Appl. No. 10/517,143
Amendment dated August 23, 2006
Reply to Office Action of May 30, 2006

AMENDMENTS TO THE DRAWINGS:

Fig. 3 Exhibit A

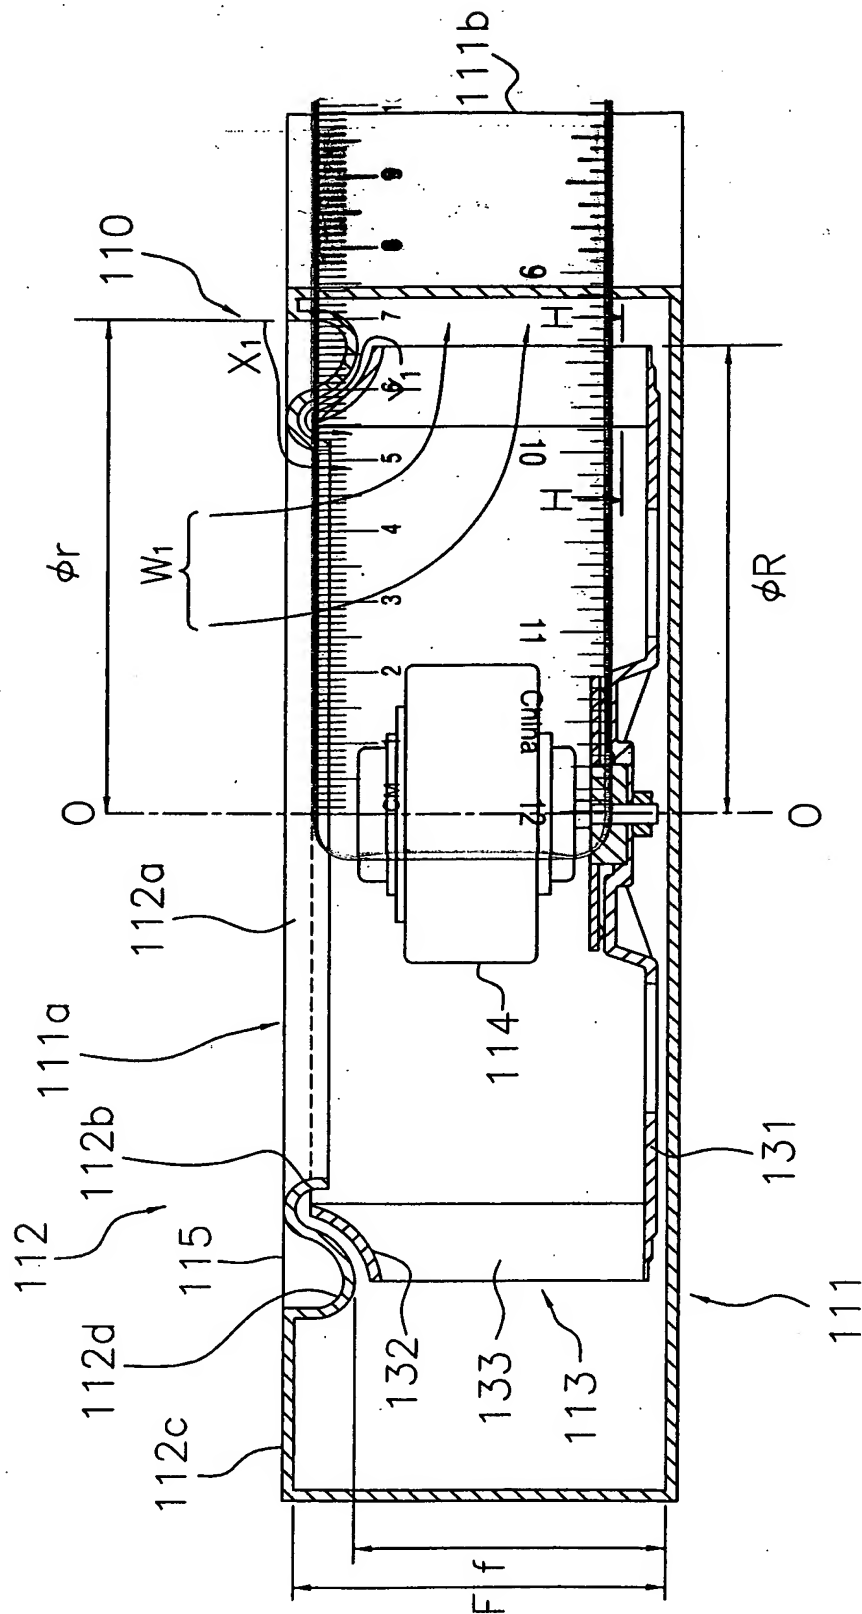
On page 2 of the Office Action, the drawings were objected to as failing to comply with 37 CFR §1.83(a).

Referring to Exhibit A in Applicant's Remarks, a ruler is superimposed on amended Figure 3. As can be seen from Exhibit A, the first length (ϕr) is illustrated with a length of about 7 cm and the outer radius (ϕR) is illustrated with a length of about 6.6 cm. Thus, the ratio $\frac{(\phi r)}{(\phi R)} \approx \frac{7}{6.6} \approx 1.09$ is illustrated in Figure 3. Accordingly, a ratio between the claimed range of greater than or equal to 0.8 to less than 1.4 is shown in Figure 3. The objection in the Office Action referred to a ratio less than 1. It is unclear why a ratio less than 1 is needed to be shown. Applicant respectfully submits that the drawings comply with

The attached sheet of drawings includes a change to Figure 3. Specifically, the dimensions of the first length (ϕr) and the outer radius (ϕR) are shown. This sheet, which includes Figure 3, replaces the original sheet including Figure 3.

The dimensions of the first length (ϕr) and the outer radius (ϕR) and the connecting portion (D) are illustrated in Figure 5, which is an enlarged view of Figure 3. Applicant submits herewith an amended Figure 3 that shows the dimensions of the first length (ϕr) from the rotational axis (O-O) to the connecting portion (D) and the outer radius (ϕR) of the impeller 113.

37 CFR 1.83(a) since a ratio within the claimed range is illustrated. Applicant respectfully requests withdrawal of the objections.
